SERVICE BULLETIN
1-800-237-0022

SUBJECT: Holland Fifth Wheel pin installation.

EFFECTIVITY: All new Holland load cell installations.

Figure 1

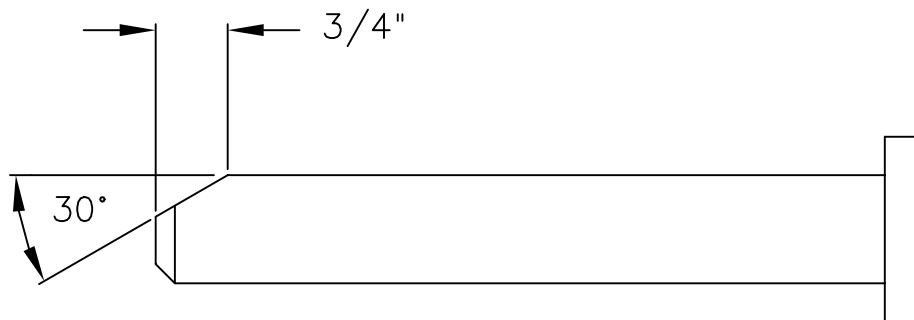
PROBLEM: Sometimes the fit between the knob on the load cell and the pocket in the fifth wheel is tight. This may make it difficult to insert the retaining pin through both fifth wheel ears.

SOLUTION: Grind a bevel on the end of the Holland Fifth Wheel pin as shown in Figure 1. When properly aligned, the bevel will compress the bushing in the knob. Use a hammer to drive the pin into place
